Product hierarchy no. *			Part no.	SBU	Type / Description	Customer part no.
SBU	PG	PGU Type				
02	007	043	0000002295	4795.0000	Connectors	4795 Cord connector

2 Type of change

Kind of document	Document number	Remarks
PCN	0118.2109	Cable guard new with square flange

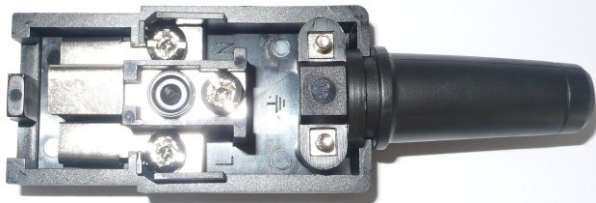
With the production of the new tool the opening for the cable guard has changed too.

The flange of the cable guard was round, what caused an insufficient hold of the cable guard.

NEW the flange of the cable guard is square, what improves the holding of the cable guard.

To pass the stronger test requirements according to IEC 60320-1 (Sect. 22: Cords and their connection), flange and slot on the cable guard had to be reinforced. As there have been made new tools for the moulding parts the holding of the cable guard got improved with a round opening.

Form: Square flange on the cable guard
Fit: n/a
Function: Better holding of the cable guard
Production Site: n/a
Product Label: n/a
